# UNITED STATES PATENT AND TRADEMARK OFFICE

10/695,038

# Office Action Summary

## DETAILED ACTION

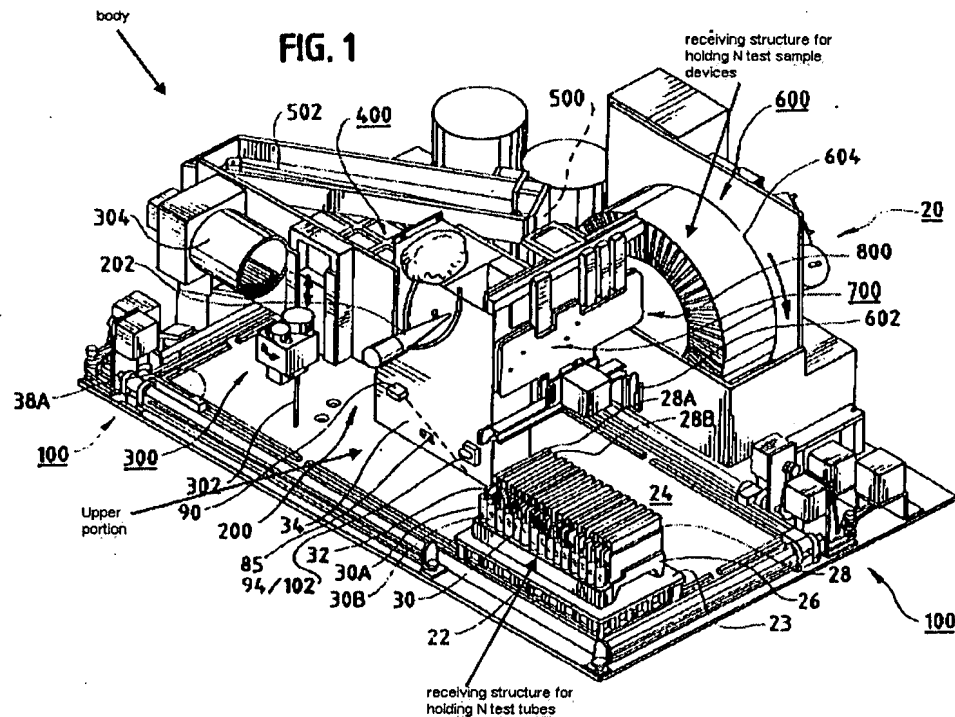
Stevens teaches a test tube tray/carrier comprising alphanumerical indicia (205) provided on the carrier 1 to N with the receiving structures. (See Figure 7)

It would have been obvious to a person of ordinary skill in the art to modify the device of Maes to provide alphanumerical indicia numerals provided on the carrier 1 to N in registry with the receiving structures in order to assist the operator in proper location of the test samples in the slots.
